Subject ▶ Change on slide plate and base

For Models ▶ LS1030 (Miter Saw)

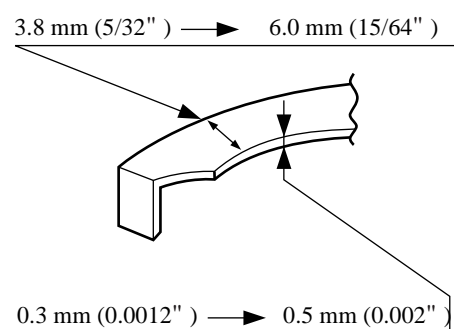
1. The slide plates will be changed from 0.3 mm (0.0012") to 0.5 mm (0.002") in thickness and 3.8 mm (5/32") to 6.0 mm (15/64") in width.

2. The rubber pins will be discontinued.

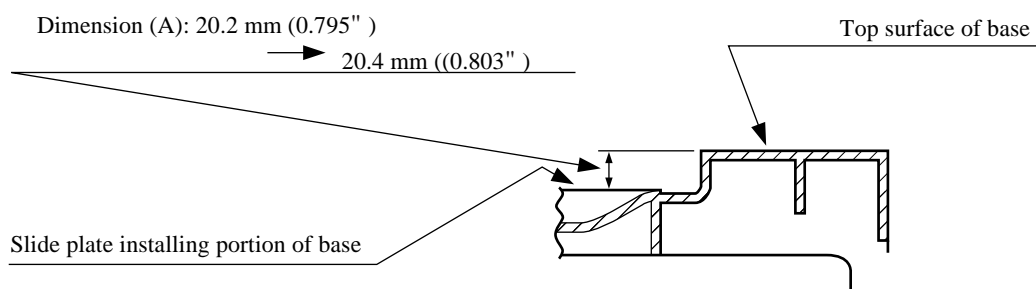
3. The slide plate installing portion of the base will be lowered. So the dimension (A) will be changed from 20.2 mm (0.795") to 20.4 mm (0.803"). The current type base and the new type base are interchangeable.
